# Zoning Staff Report

**Case Number:** ZC-23-080

## Zoning Map Amendment

**Site Location:** 2700 & 2704 Lipscomb Street

SITE PLAN

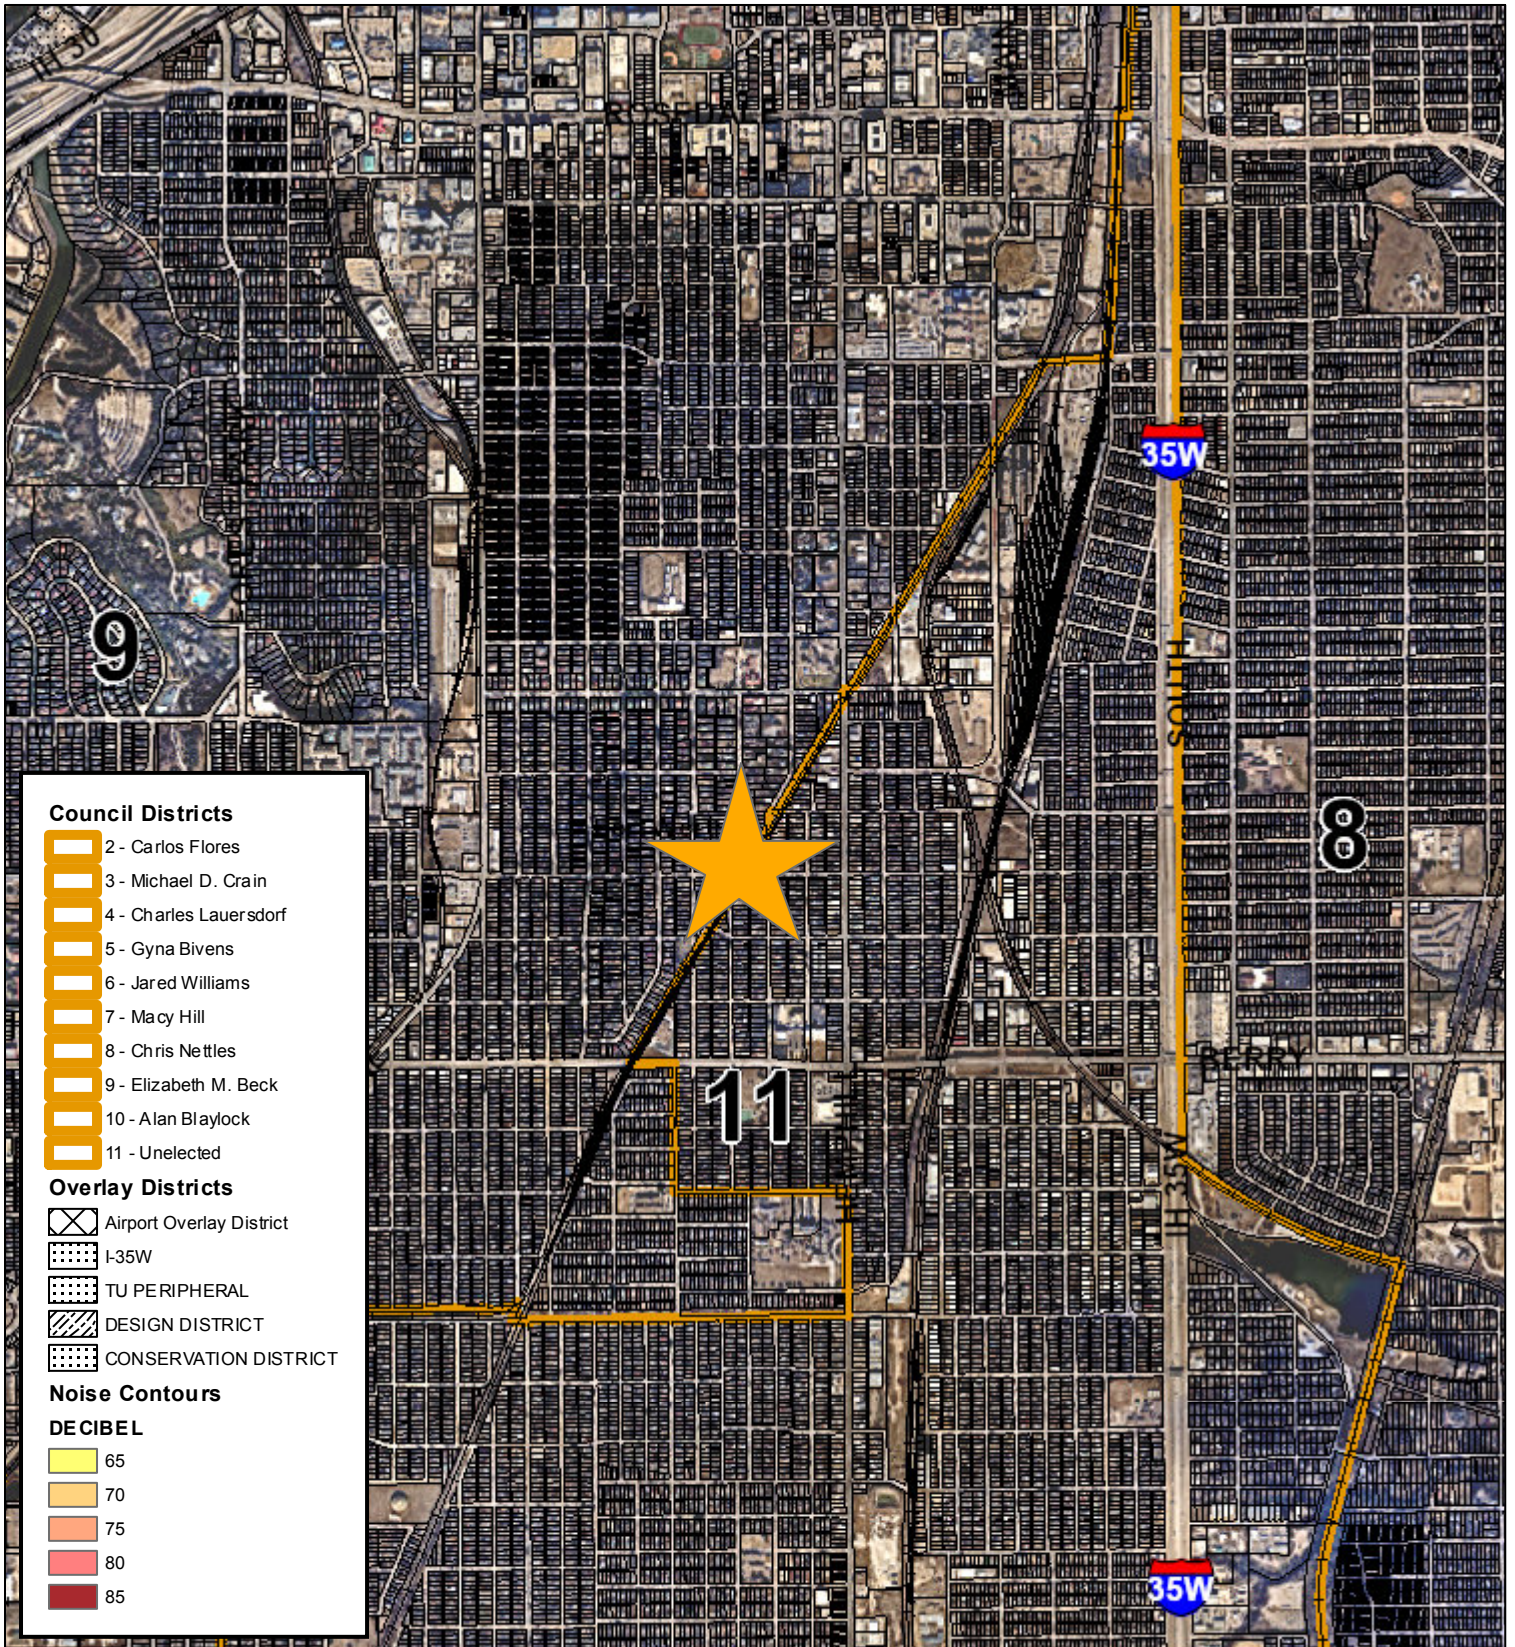
- The site plan is not in general compliance with the Zoning Ordinance regulations for UR- Urban Residential. **The applicant is requesting a PD to waive the following:**

- Allow one parking space in the front yard setback along W Capps, as shown on the site plan.
  - 5' Landscaped buffer yard along the railroad (A5) is not required.

- Staff has reviewed the site plan that was submitted at the application; here are the notes:
  - **Parking Requirements**
    - **Per Ord. 4.1300.e.1-** Townhouses require 2 spaces per dwelling unit or 1 space per dwelling unit if the development is within 1,320 feet of a rail station. This project is not within a rail station so the requirement for this project is two parking spaces per dwelling unit. This project has 15 units so the minimum requirement is 30 parking spaces.

- **Per Ord. 4.1300.f.3-** UR district is intended to create a public environment in which pedestrian safety, comfort, and interest are paramount. Therefore, parking areas that front public streets and pedestrian pathways must be screened to minimize pedestrians' view of parked vehicles and the impact of vehicle headlights. Also, **Per Ord. 4.1300.f.3.a** Parking lots and driveways that are located adjacent and parallel to a public street must be screened from the public right-of-way with landscaping, fences, or walls a minimum of 3 feet in height measured from parking lot grade to a maximum of 4 feet in height.

- **Residential Entries**
    - **Per Ord. 4.1300.g.4.e.3-** Townhouse must have individual street-oriented entries for each unit space. The site plan provided does not comply with this ordinance, all of the residential entries are in the back

- **Setback Requirements**
    - **Per Ord. 4.1300.d.2 -** Townhouse must comply with the setback requirements. Currently, building 4 is greater than 20' and is not in compliance with the rear setback, the maximum allowance is 20'

- **Enhanced Landscaping and Pedestrian Lighting Requirements**
    - **Per Ord. 4.1300.f.2-** The site plan is not in compliance with this ordinance when it comes to all ROW. The created access drive and the alley are considered ROW in the UR district. Those ROW must include enhanced landscape and pedestrian lighting. The current site plan will need a waiver or to be updated to comply with the Ordinance.

- **Facade Variation Requirements**
    - **Per Ord. 4.1300.g.2.a-** Each new building facade that is greater than 50 feet in width and is oriented to a publicly accessible street or open space must incorporate each of the following scaling elements. For building facades less than 50 feet in width, a minimum of two elements are required. The site plan did not include elevations to show the façade variations. Staff can not determine if a waiver will be needed, but staff will need to review it before any approved site plan.

- **Per Ord. 4.1300.g.2.b-** New building facades oriented to a publicly accessible street or open space must include differentiation between the first and the upper levels with a canopy, balcony, arcade, or other architectural features.

- **Per Ord. 4.1300.g.2.c-** The project consists of more than one block face, each sequential block of new construction must contain a different building facade to encourage architectural variety within large projects, using the required architectural elements listed in Section (g)(2)a above and/or other architectural features.

- **Building Materials Requirements**
  - **Per Ord. 4.1300.g.3-** Each new building facade that is greater than 50 feet in width and is oriented to a publicly accessible street or open space must incorporate each of the following scaling elements. For building facades less than 50 feet in width, a minimum of two elements are required. The site plan did not include elevations to show the façade variations. Staff cannot determine if a waiver will be needed, but staff will need to review it before any approved site plan.

- **Service Areas Screening Requirements**
  - **Per Ord. 4.1300.h.3-** Trash and recycling collection, and other similar service areas, must be located to the side or rear of buildings and behind the primary structures on street frontages.

- **Per Ord. 4.1300.h.4-** Wall, roof or ground mounting requires screening.
  - **Per Ord. 4.1300.h.5-** Private streets and drives with public access easements shall be considered public streets or right-of-way for the purpose of review for compliance with setbacks, pocket parks, parking, screening, enhanced landscaping, facade variations, fenestration, and other UR design requirements normally based on streets.
